ITEM #4: For the **ARCHITECTURAL COMMISSION** on **MONDAY, October 20th @ 7:00 P.M.**

REQUEST: Consideration of the final site plan, landscaping, lighting, signage and elevation plans as part of an application by Harbor Retirement Associates for an amendment to the previously approved Special Use Permit and Planned Unit Development known as the Fairfield Village Planned Unit Development and within the R-2 PUD District to provide for a senior living center with Memory Care and Assisted Living Facilities for the property at 1190 Old McHenry Road, submitted by Harbor Retirement Associates.

**Harborchase
of Long Grove**
Senior Living Community

**BUILDING
ELEVATIONS**

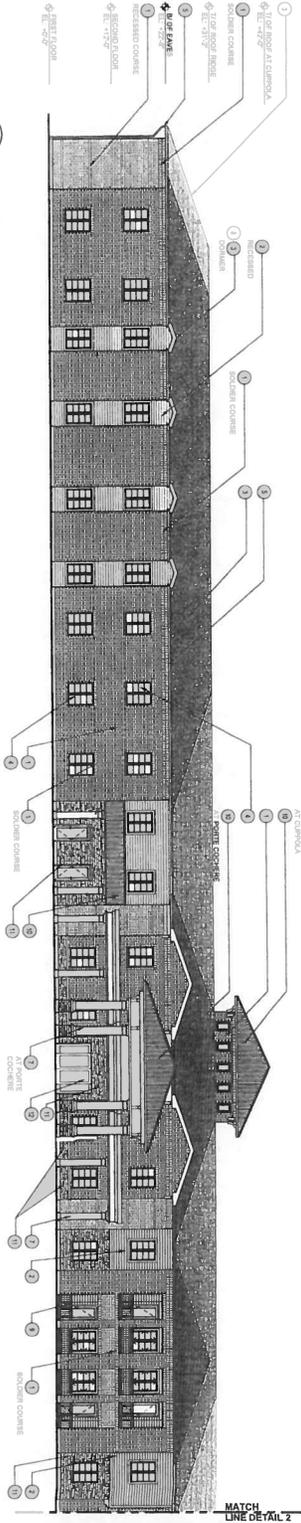
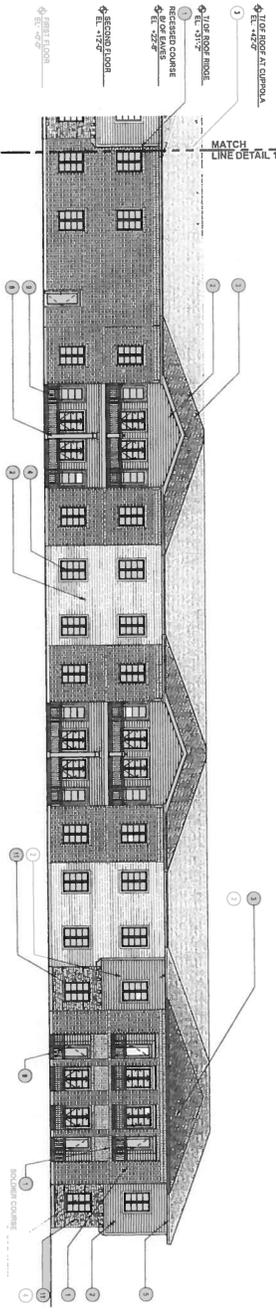
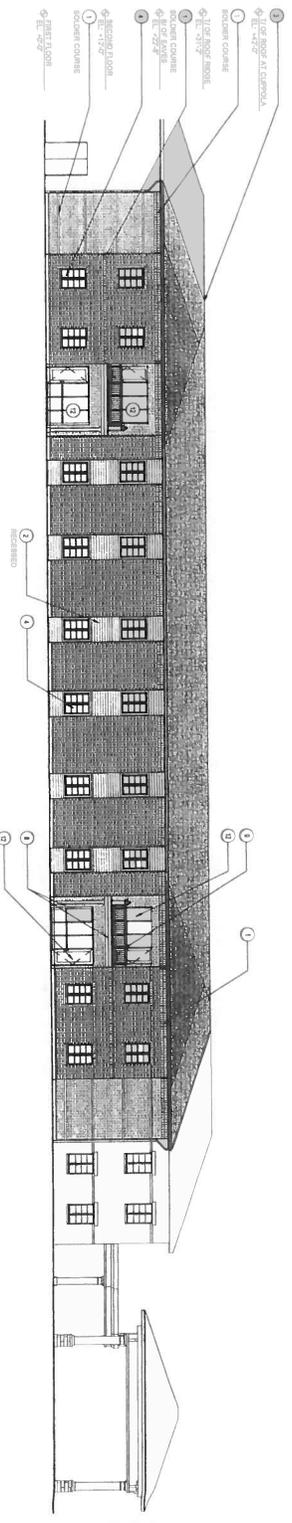
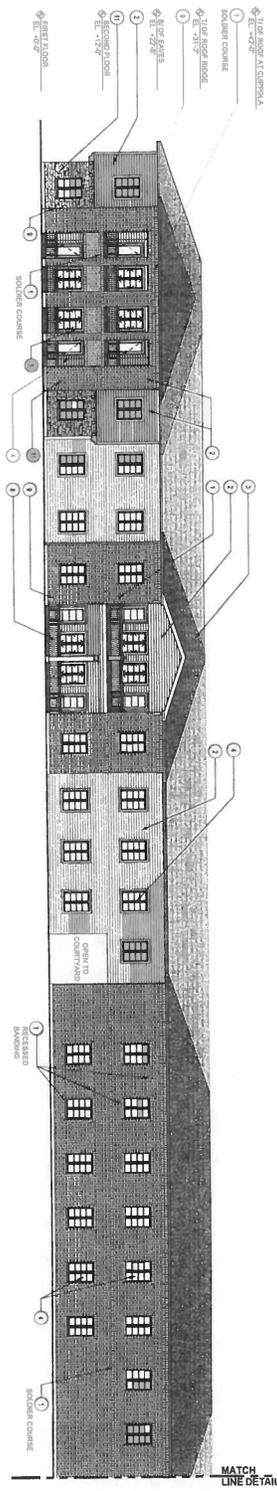
At the June AC meeting the Commission reviewed the preliminary elevations for the structure. While generally positive the Commission raised a concern with east elevation of the structure and large expanse of brick and windows from the "at porte cochere" to the south end of the building and the look of this from Rt. 83. It was suggested the petitioner considered modifications to the roof lines to relieve the monotony.

A motion was made by Commissioner Calas, seconded by Commissioner Closson; to accept the preliminary elevations for the proposed structure as submitted with the condition that the roof lines be altered on the east elevation to minimize the monotony of the structure. On a voice vote; all aye.

In general the final plans are in "substantial compliance" with the preliminary plans. Modifications in have been made to address the condition on the approval as recommended by the AC. These consist of the addition of dormers above the recessed windows along the east and west elevations. A side from this modification the proposed structure is consistent in terms of height, configuration and building materials with the preliminary plans as submitted and approved.

The AC needs to review the revised elevations per their initial comments and concerns.

FINAL P.U.D. FOR HARBORCHASE of LONG GROVE, ILLINOIS

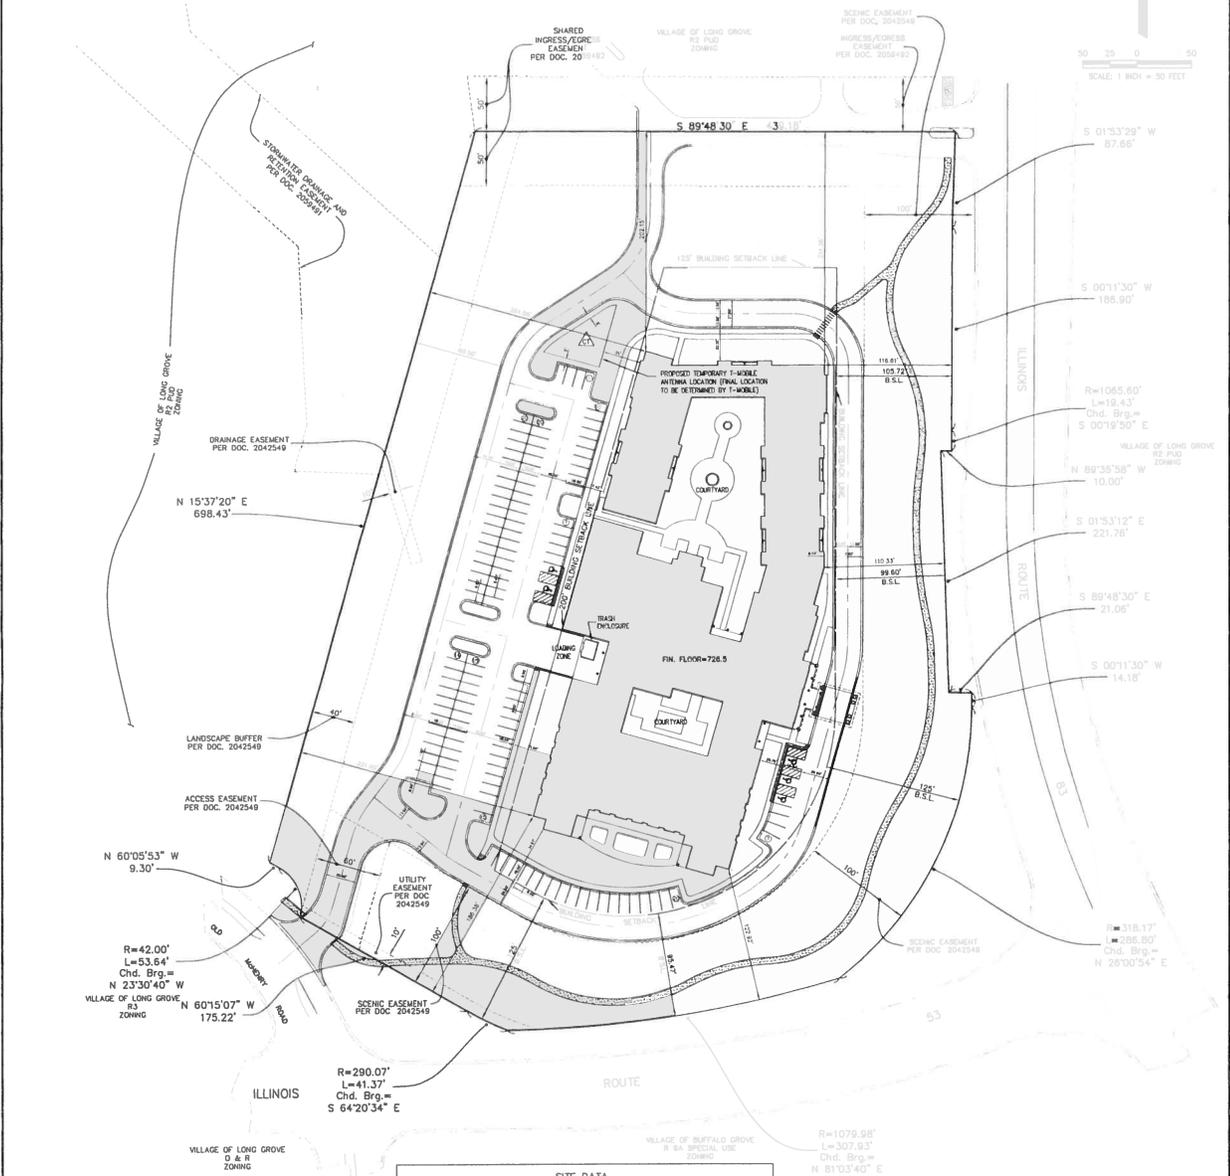
Additionally, the existing cell tower is proposed of be located temporarily to the north and west of the principal structure. This is more or less consistent with the general temporary location for the tower as preliminarily proposed.

Staff notes that this location is spelled out in the in the final engineering plans but not the final site plan. Staff suggests this location be consistent on both plans.

The site plan/plat as submitted by the petitioner has been carefully crafted to work within the constraints of the approved PUD. These constraints have been an impediment to redevelopment of this property. Of note the site plan is more or less consistent with the current configuration of the site and works within the plat constraints of the PUD as well. The temporary location of the cell tower should be content on the site plan and plat however.
